Reference: Septic System Design Revision
Randall Johnson Property

Randall Johnson Property - File No. 03-5-833

On-Site Wastewater Design Specifications

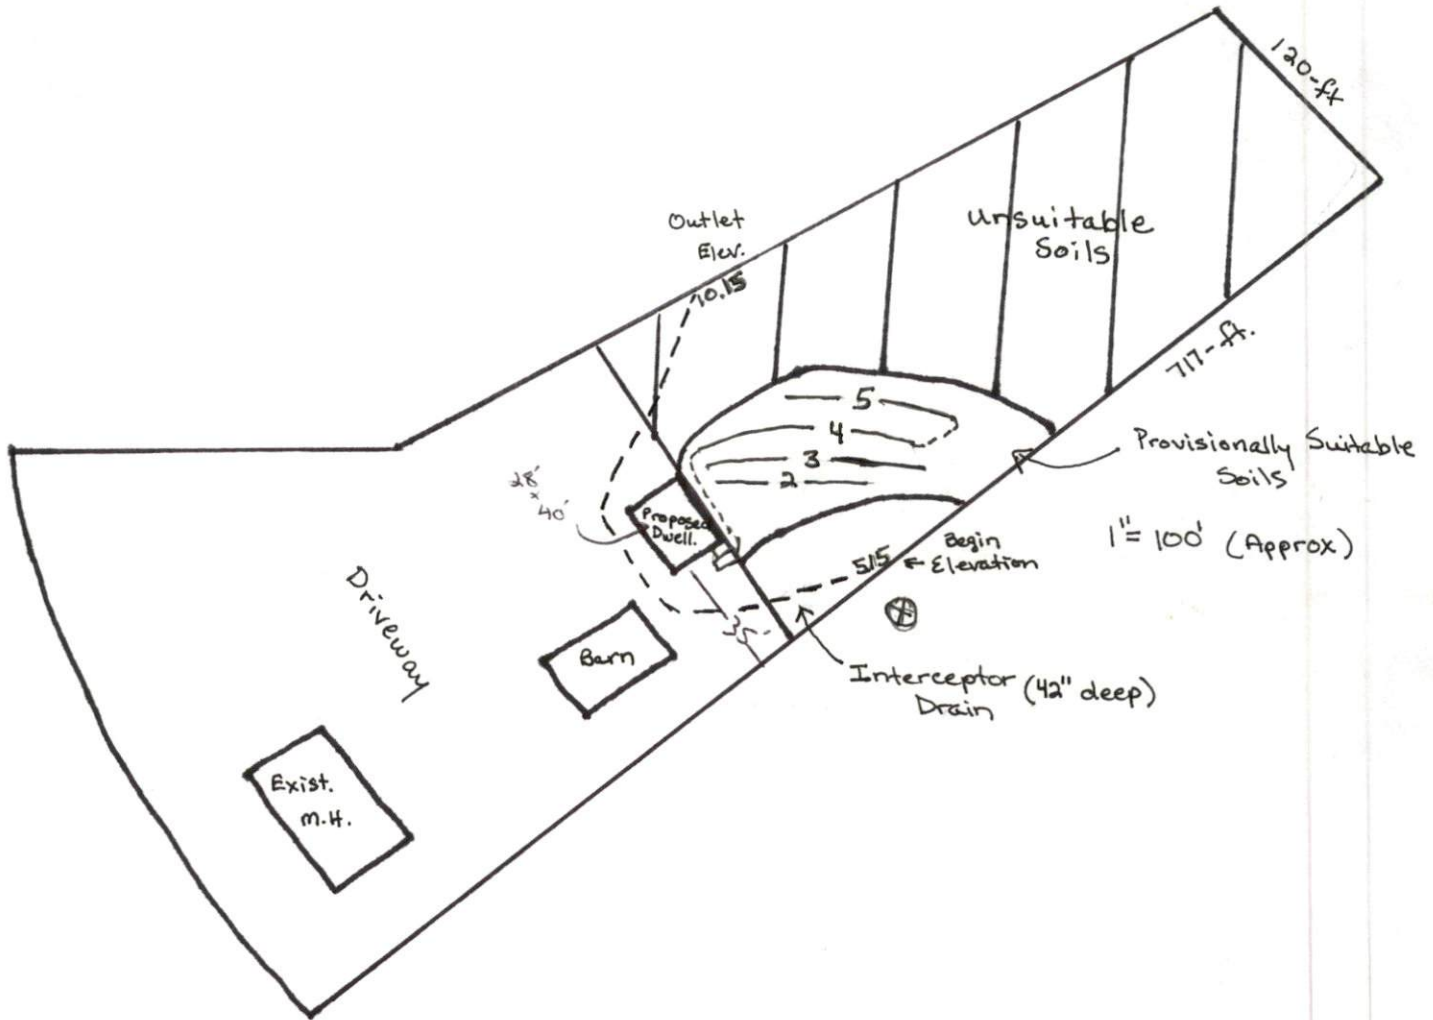
After our site meeting at the above referenced property, I have modified the septic system design to reflect a 0.6 gpd/sqft application rate as assigned by Dr. David McCloy, the regional soil scientist. Both the initial and repair septic systems are proposed utilizing 200-ft of conventional drainlines that will be fed via gravity and distributed serially on contour at an 18 inch trench depth. It was established at this meeting that an interceptor drain (blind ditch) will be required above the proposed septic systems and that it is to be installed prior to construction. Attached is the schematic showing both the proposed drainfields and the proposed location for the interceptor drain. The surface elevation from the top of the hill to the ditch along the property line is 5-ft. I understand that the interceptor drain must be at least 42 inches deep uphill from the septic system and gradually come to surface in the existing ditch below the house. The existing ditches will likely need improved to aid in proper disposal of the water from the interceptor drain to the final outlet at the large ditch along the property line. The interceptor drain is mapped in front of the proposed dwelling in order to maintain proper setbacks from the drainfield.

Initial System: Gravity Serial Distr. Conventional (200-ft)
 on contour at: 18 inches
 LTAR: 0.6 gpd/sqft
 Repair System: Gravity Serial Distr. Conventional (200-ft)
 on contour at: 18 inches
 LTAR: 0.6 gpd/sqft

Lines flagged at site on 9-ft centers.
